APPEAL SUMMARY

Appeal ID: 27614	Project Address: 14321 NE Whitaker Way
Hearing Date: 3/30/22	Appellant Name: Jonathan Dunn
Case No.: B-005	Appellant Phone: 503.889.0604
Appeal Type: Building	Plans Examiner/Inspector: Chanel Horn
Project Type: commercial	Stories: 1 Occupancy: B, F-1, H4 Construction Type: V-B
Building/Business Name: Unifirst Corp	Fire Sprinklers: Yes -
Appeal Involves: Alteration of an existing structure	LUR or Permit Application No.: 21-096562-CO
Plan Submitted Option: pdf [File 1] [File 2]	Proposed use: Manufacturing

Appeal item 1

UNIFIRST ROOF REPAIR
14321 NE WHITAKER WAY
PORTLAND, OR 97230

1 ROOF PLAN

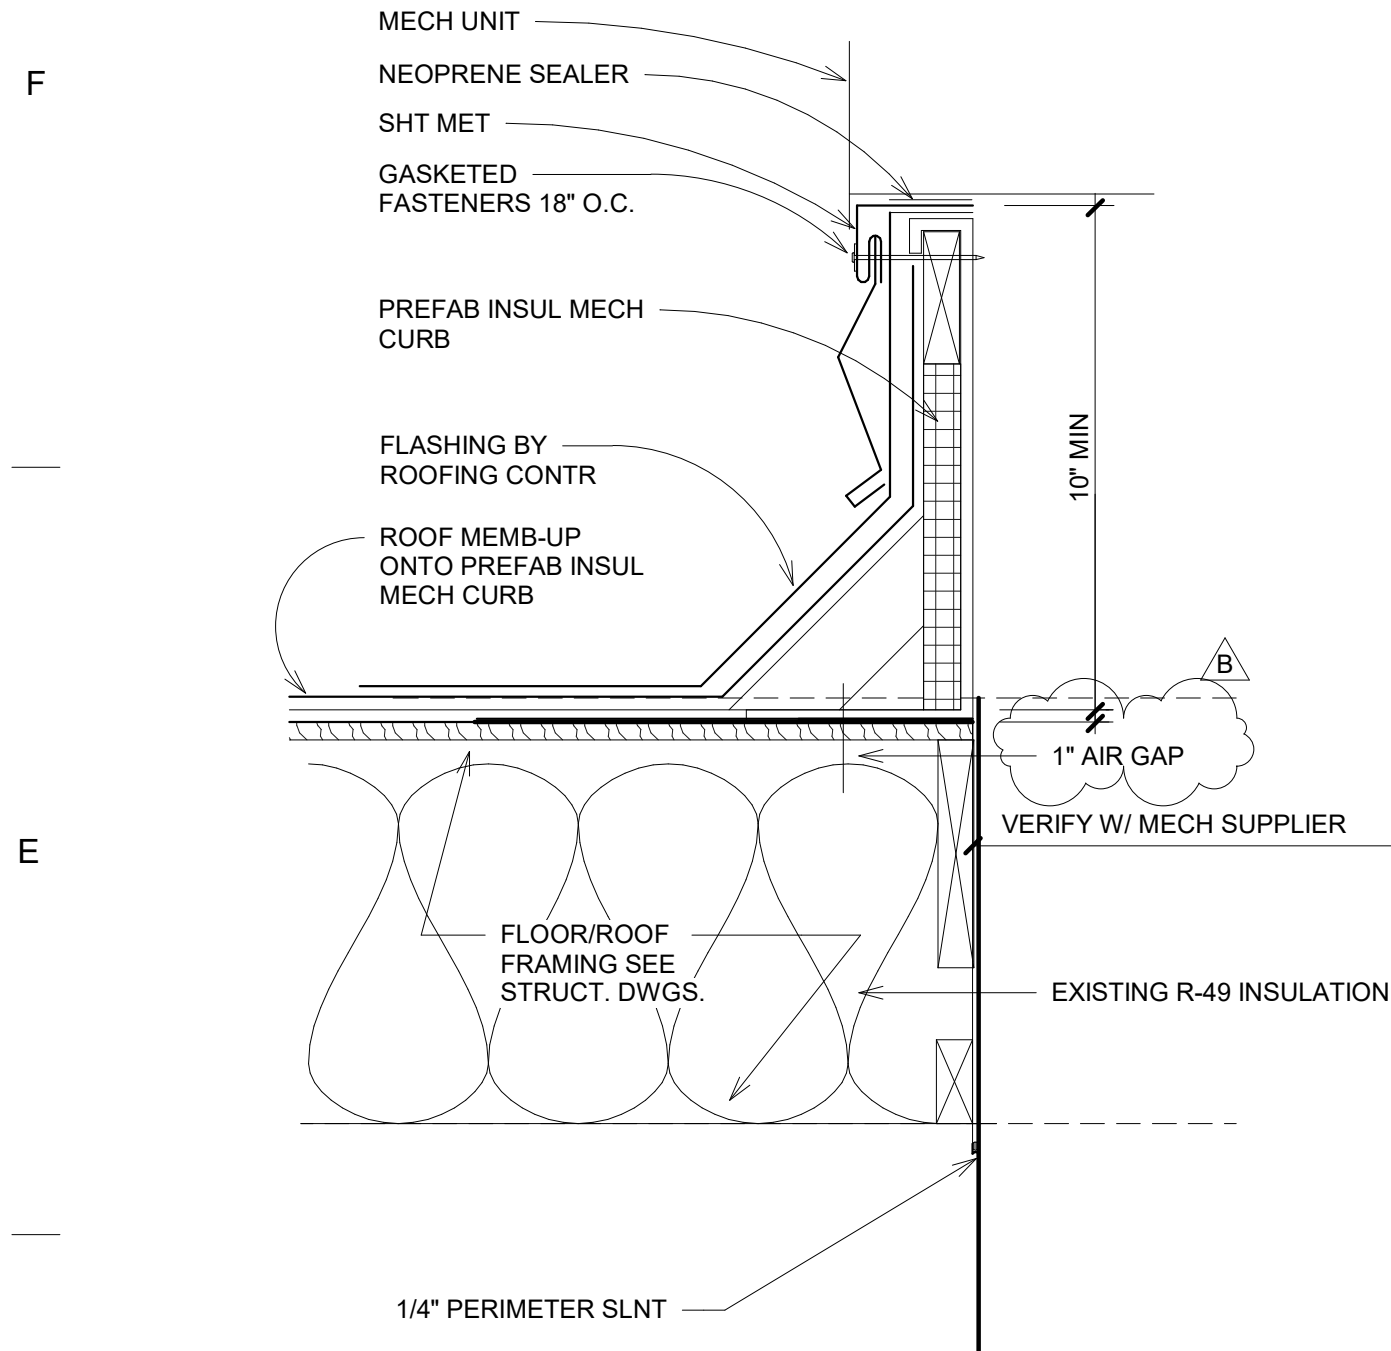
Code Section	1011.12.2
Requires	Code section 1011.12.2 is being misapplied. Permit review comment to please provide a roof hatch that is a minimum 8 feet (96 inches), instead of 42 inches, long. (1011.12.2, Exception)
Code Modification or Alternate Requested	The code section 1011.12.2 exception quoted to require the minimum 8' long roof hatch is being incorrectly applied to a building less than four stories.
Proposed Design	There is no minimum size requirement for a roof hatch accessed from a ships ladder for a building under four stories, with no elevator. Code Seciton 1011.12 and the subsequent exception does not apply. A 42" x 42" standard roof hatch is acceptable provided adequate clearances are provided. A building under four stories does not require roof access to an unoccupied roof without equipment requiring access by the building code. A roof access over 16' in height per Oregon Mechanical Code 306.5 shall have exterior or interior means of access.

Reason for alternative	<p>The code only requires access, in the form of stairs, to a roof for buildings four stories or more. The penthouse, or roof hatch exception (1011.12.2) is only applicable when stairs are required by section 1011.12. Following basic code hierarchy, Section 1011.12.2 is a subsection to Section 1011.12. If Section 1011.12 is not in play then the subsections are also not in play. We see no citable path to require a specific sized roof hatch for a building less that four stories. A roof hatch may be provided for access to mechanical equipment on a roof, but there is no citable minimum size. The 42" x 42" roof hatch meets all required clearances of the OMSC for access from a ships ladder. OAR 918-098-1900 requires citation of the exact code reference applicable. In this case, the code reference is not applicable.</p> <p>Additionally, the operation of a roof hatch this large from a vertical ladder or ships ladder is hazardous due to the reach required to close and operate such a large opening and the standard</p>

location of the latch hardware. By the logic of this review comment an exception to a subsection of code for buildings over four stories applies to all buildings, thus all roof hatches regardless of building size would require a minimum dimensional standard of 30" x 8'-0".

- 100 EXISTING SKYLIGHT TO BE REPAIRED, TYP. SEE DETAIL 5/A500
- 101 GUARDIAN CB-12 STEEL POST ANCHOR POINT WITH SAFETY TAPING, TYP.
- 102 RE-SHEATH AND RE-ROOF WITH TPO TO REPAIR DAMAGE ON ENTIREITY OF ROOF SURFACE. EXISTING R-49 BATT INSULATION AT UNDERSIDE OF ROOF TO REMAIN.
- 103 42"x 42" ROOF HATCH. GUARDRAIL GATE 42" IN WIDTH WITH OPENING SWING LIMITATION OF 90 DEGREES.

Determination of roof hatch minimum size requirement in a one story building: Granted as proposed.
